Bayswater Water and Other Associated Operational Works Project
Environmental Impact Statement Response to Submissions Report

IS353800_RtS | Final

AGL Macquarie Pty Ltd

Figure 2.1 Ravensworth ash line revised footprint and constraints

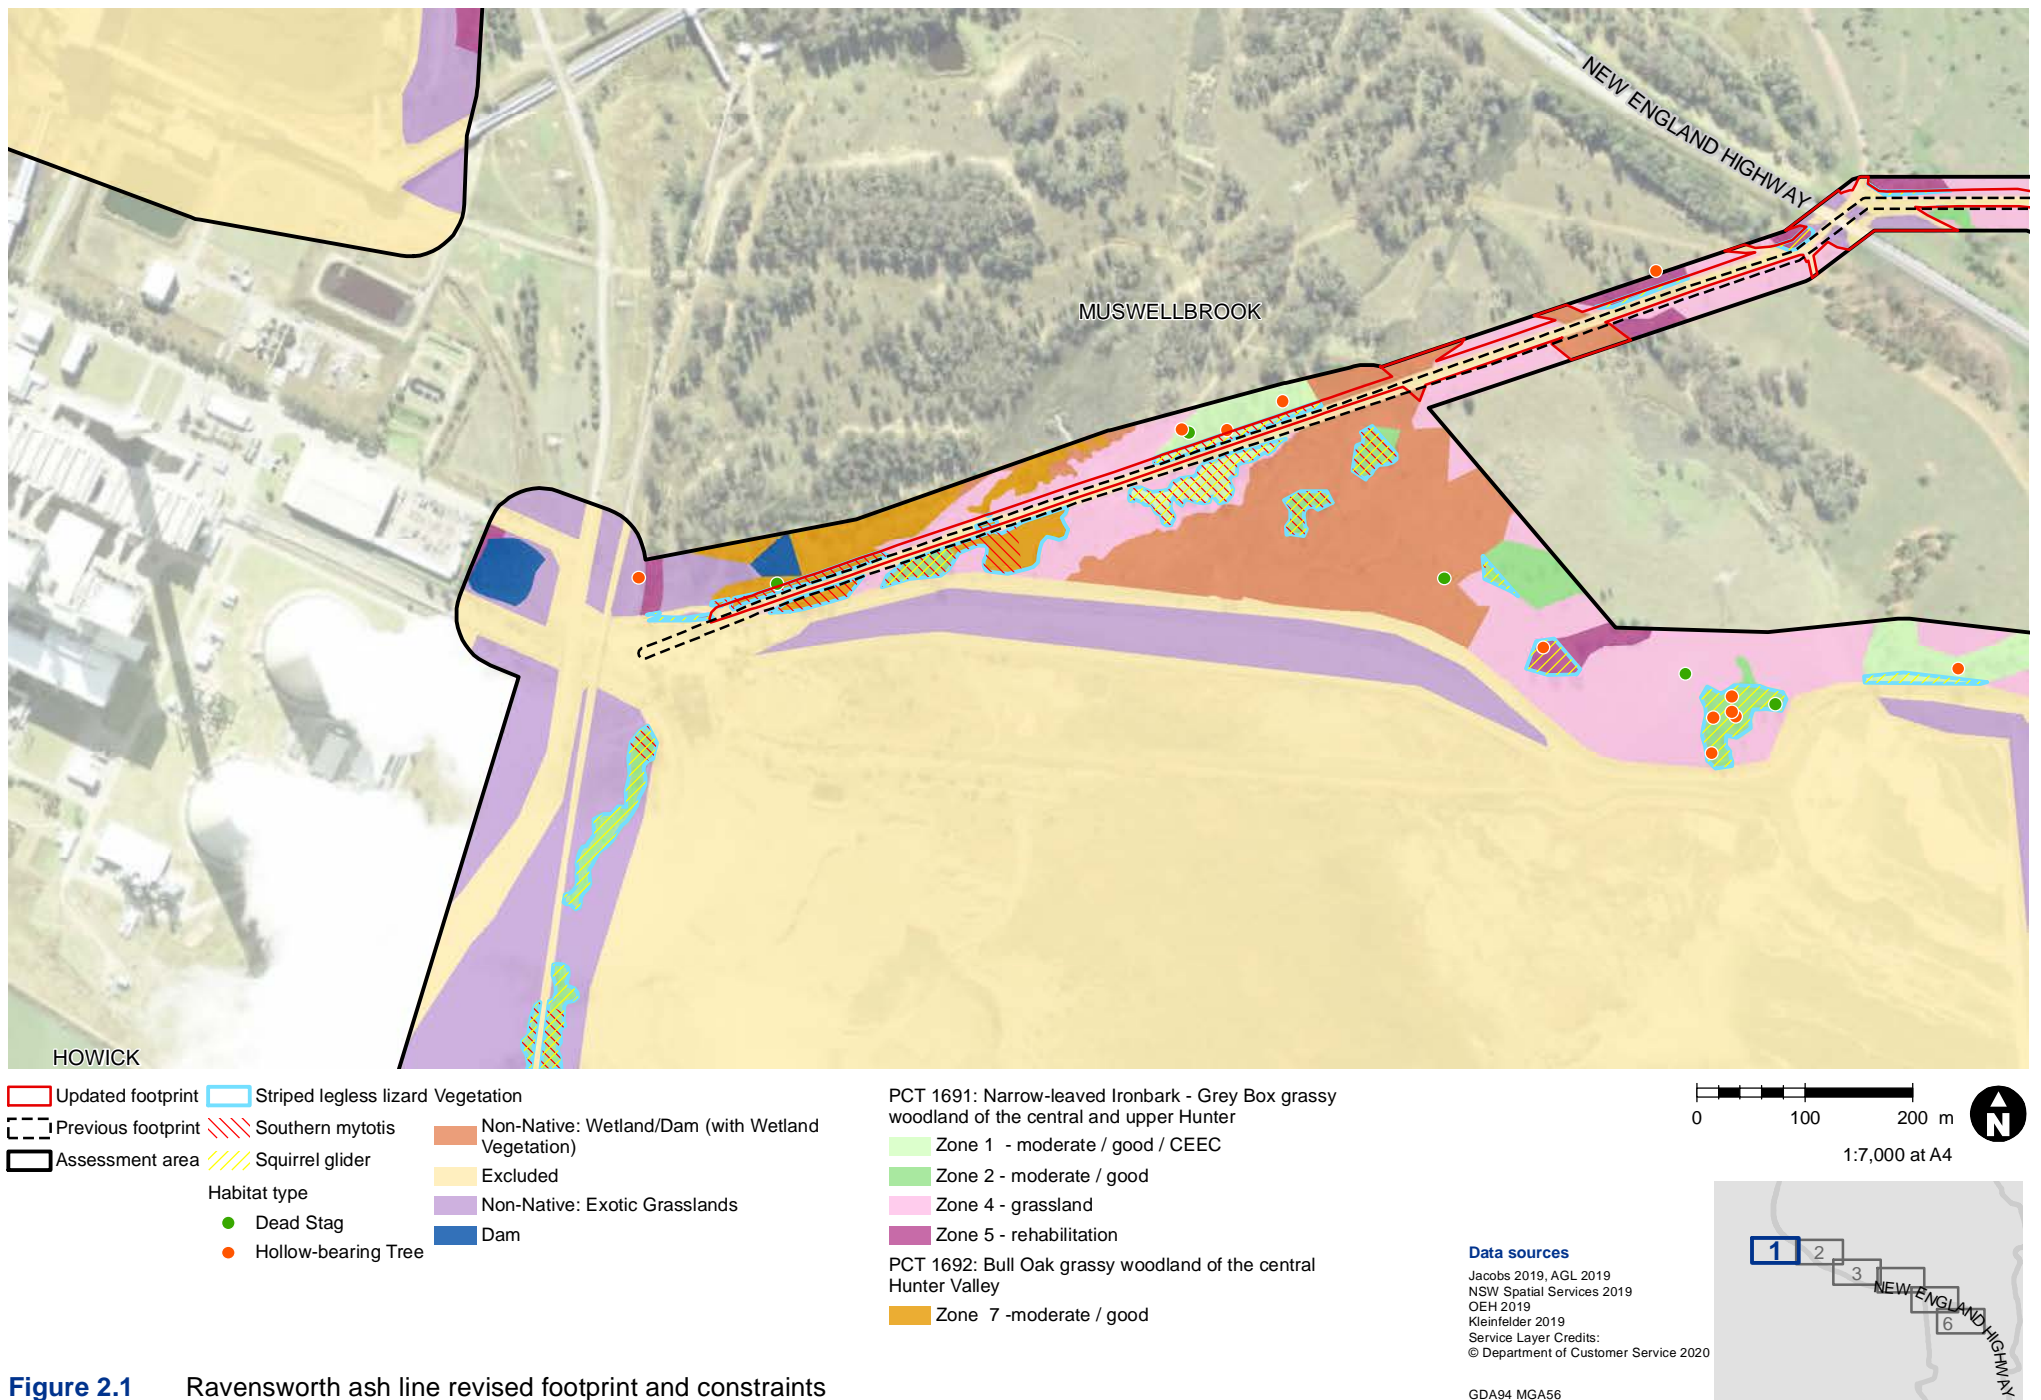
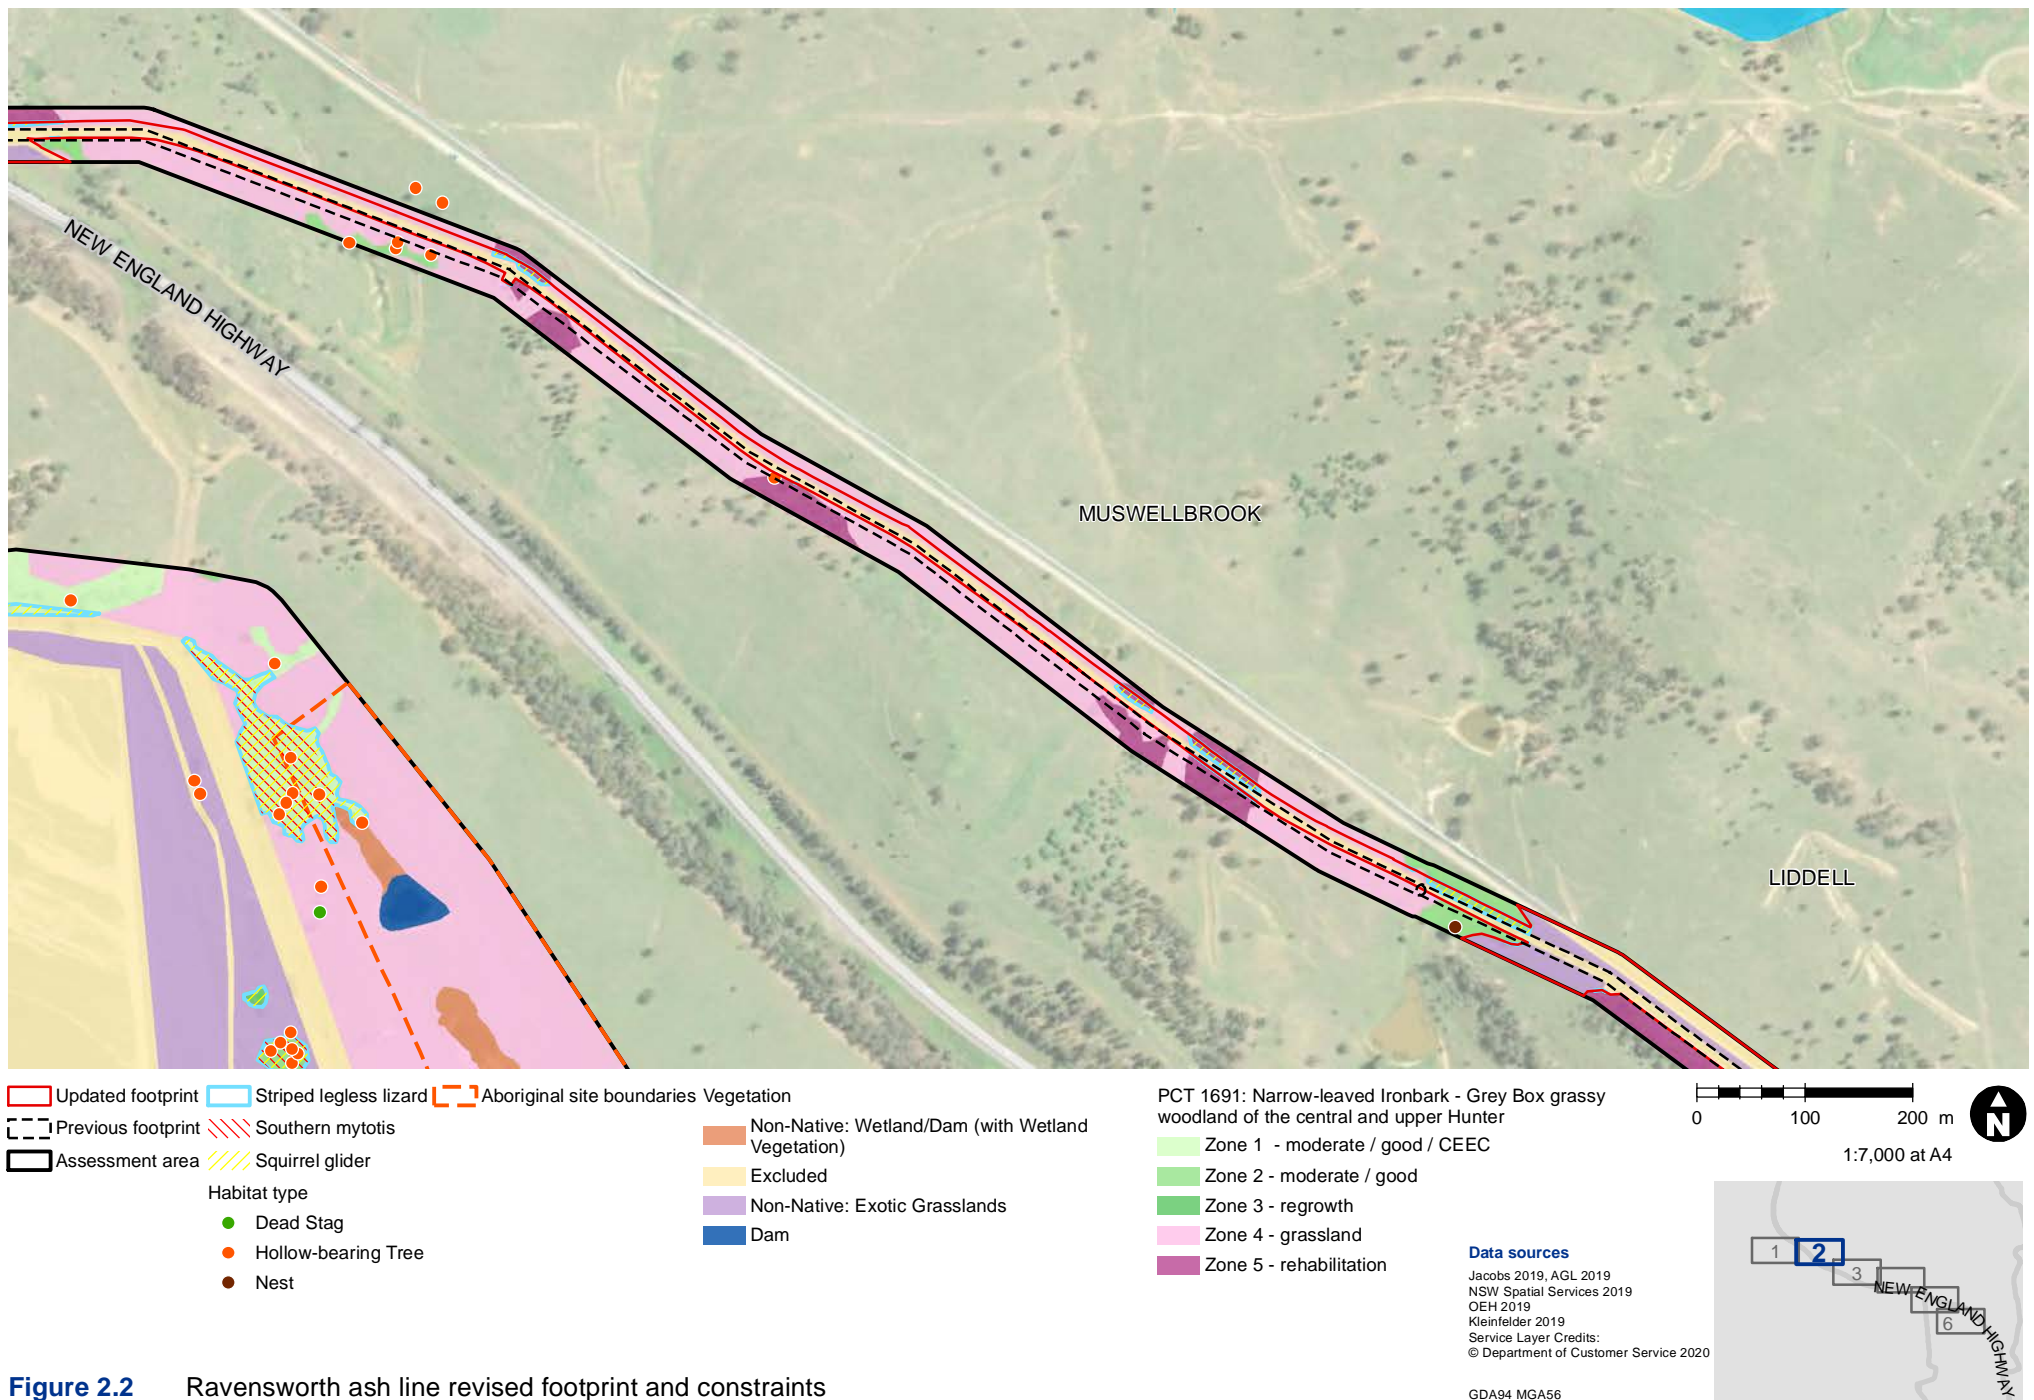
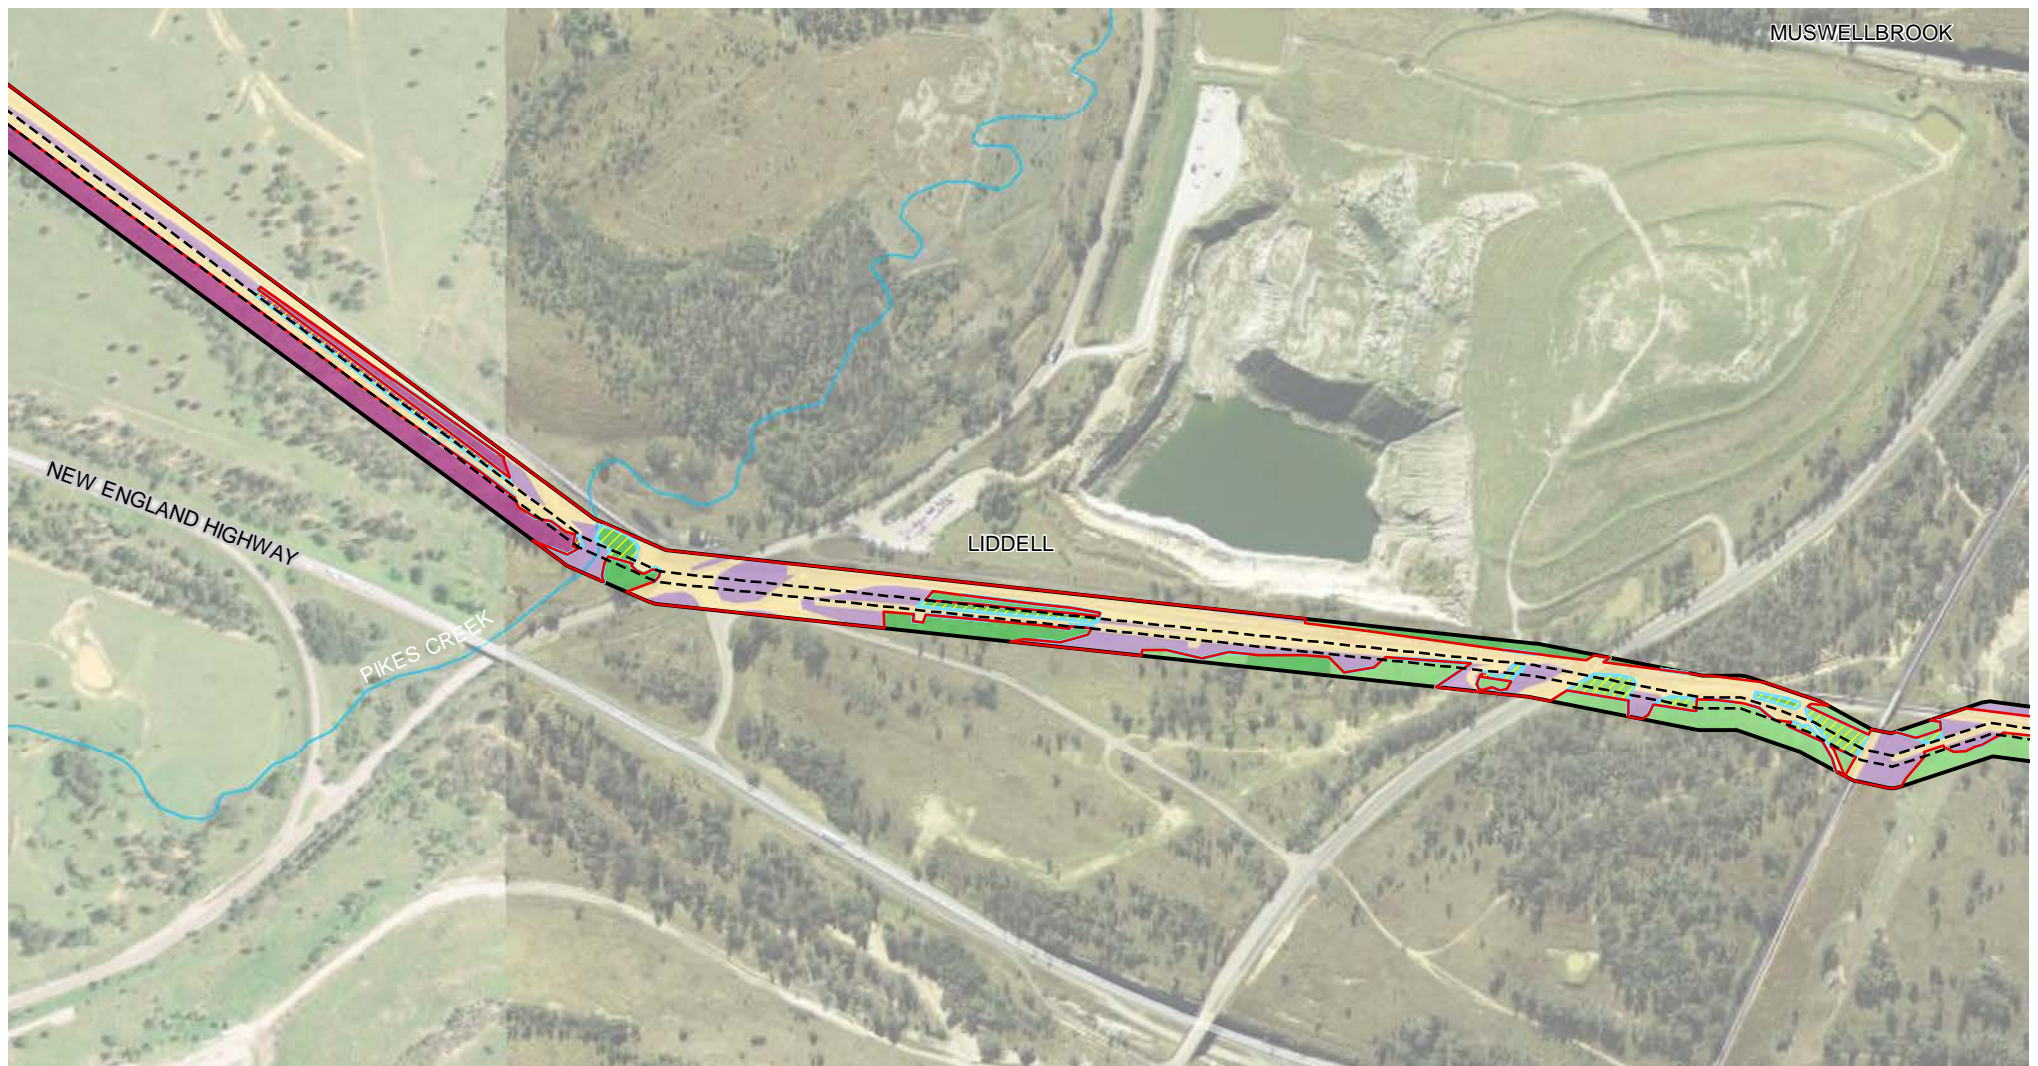
- More than one pipeline may be an option for final design noting that the existing Ravensworth pipeline consists of two adjacent pipelines and the new wording is added for completeness

- Impacts on 200.64 hectares (**ha**) of Plant Community Type (**PCT**) 1691, generating a credit obligation of 3780 ecosystem credits (reduced from 206.82 ha and 3,904 credits)

- Impacts on Paddock Trees associated with PCT 1691 requires a total of 31 ecosystem credits (no change)
- Impacts on 55.08 ha of Squirrel Glider habitat, generating a credit obligation of 1346 species credits (reduced from 59.05 ha and 1,433 credits)

- Impacts on 8.11 ha of Southern Myotis habitat, generating a credit obligation of 233 species credits (no change)
- Impacts on 116.74 ha of Striped Legless Lizard habitat, generating a credit obligation of 2,102 species credits (reduced from 120.68 ha and 2169 credits).
